## ***Interactive comment on “Gauge-Adjusted Rainfall Estimates from Commercial Microwave Links” by Martin Fencel et al.***

**Martin Fencel et al.**

Received and published: 1 November 2016

**Fig. 1.** Wet antenna attenuation of about 5 dB for a 38 GHz CML almost disappears within 3-4 minutes after spraying the antenna radome during dry weather.

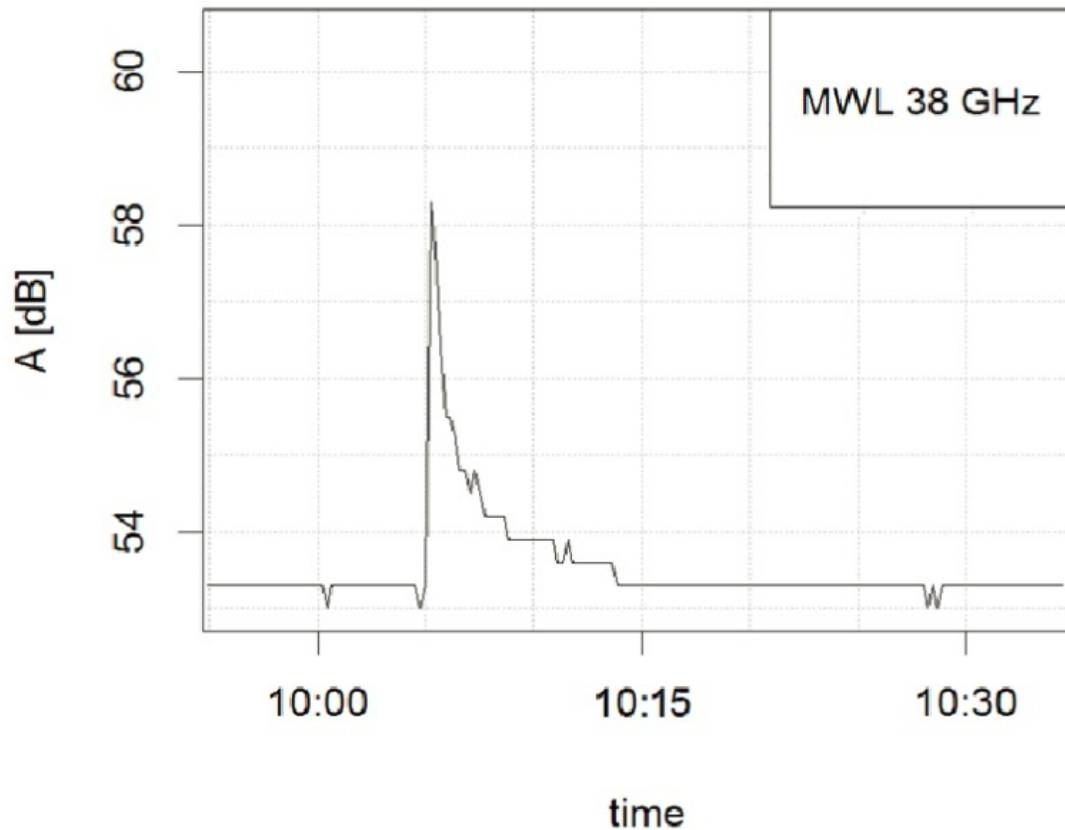
*13. On p.13, Section 4.2 the authors discuss how the distribution of the  $\gamma$  parameter changes with aggregation interval. This is then related to the fact that the proposed model includes the effect of wet antennas. However, this effect should be more related to the  $k_w$  parameter of the model, and not so much to  $\gamma$ . Of course, the two model parameters can compensate, and this would result in wider distributions of  $\gamma$ , but this is a purely an effect of the fitting procedure.*

We have a different opinion on this particular issue and presume this is rather a misunderstanding caused by the unfortunate naming the offset parameter " $k_w$ " (in the future  $\Delta$ ) of model (2) (see reply to comment 7) and its imprecise description on p. 7, lines 7-9. This might create the false impression that only the offset parameter is responsible for wet antenna attenuation (WAA) correction. It is important to note that the simpli-

fied model (2) should be interpreted as “a combination of WAA model and simplified standard power-law model” (p. 13 lines 9-10). Although Overeem et al. 2011 suggest that, for their 15 minute CML data, WAA can be satisfactorily modelled as a constant, the other authors suggest more complex models. Given our theoretical understanding, these should generally depend on rainfall intensity (e.g. Kharadly et al. 2001, Leijnse et al. 2008). Indeed, we found that WAA react very dynamically on changes in rainfall intensity. Spraying the radomes of some radios in Prague showed a substantial dynamic response. Immediately after spraying, attenuation increased by about 5 dB, decreased to 2.5 dB after 1 minute, and was almost not observable any more after 3-4 minutes (Fig. 1, this response).

If WAA depends on rainfall intensity, the linear approximation of any WAA model which reflects this dependence then should be affected by compensation of the offset parameter by the slope parameter. This also would explain (p. 13, lines 8-10) the discrepancy between  $\gamma$  parameters of model (2) and  $\alpha$  parameter of model (1) suggested by ITU (2005). Such discrepancy was already reported by Fenicia et. al (2012) “who estimated for their 23 GHz CML values of  $\alpha$  substantially lower than values suggested by ITU (2005)” (p. 13, lines 10-11).

To clarify the nature of the simplified model (Eq. 2) and avoid misunderstanding, we suggest to label  $k_w$  as  $\Delta$  instead. And also change the description of the parameters when first introducing model(2) (p. 7, lines 7 - 9). Third, we will better explain that the simplified model combines linear approximations of both the rainfall retrieval model (1) and wet antenna model in section 2.4.

**Fig. 2.** Revision of the figure 4 in the original manuscript.

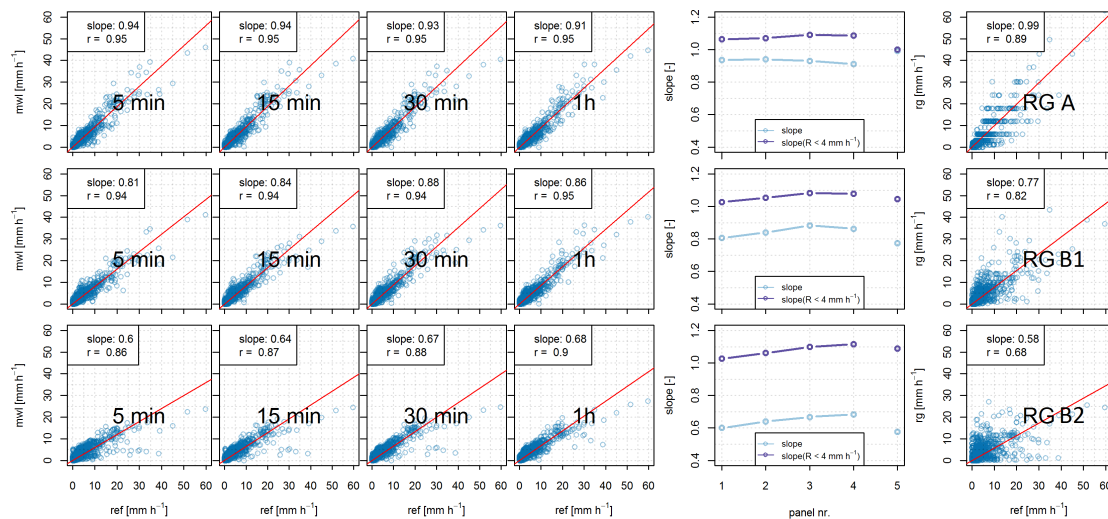
19. In Figures 3 and 4 the slope of the regression line  $y = ax$  (i.e., with fixed offset) is given. It should be noted here that the correlation between the two variables affects this slope. The slope will always be lower with a low correlation coefficient (you can try this by switching the x- and y-axes; see also the right-hand panels of Fig.4).

This is another valuable remark. We suggest to add correlation coefficients into the legends of scatterplots in both figures (see Fig. 2 in this response).

The correlation coefficients on Figure 2 (in this response) shows, that even CMLs adjusted to remote RGs correlate very well with reference rainfall. The slope of CML-reference rainfall regression line is therefore rather influenced by systematic underestimation of rainfall peaks. In contrast to that, the correlation between RG layouts which cover larger areas and reference rainfalls are much lower (at 1 min resolution), which indeed affects the slope of regression lines. However, aggregating the RG intensities over longer intervals increases the correlation. Consequently, a longer aggregation interval improves the performance of the adjusting algorithm compared to shorter aggregation (see Fig. 5 in the manuscript: in the case of layout B2 with relatively distant RGs - the  $NSE$  of 1h ranges between 0.50-0.91 with median 0.78, whereas 5 min only achieves  $NSE$  between 0.2-0.86 with median 0.75). The areal averaging leads, however, to the smoothing out of rainfall peaks which in turn systematically affects peak rainfalls estimated from adjusted CMLs.
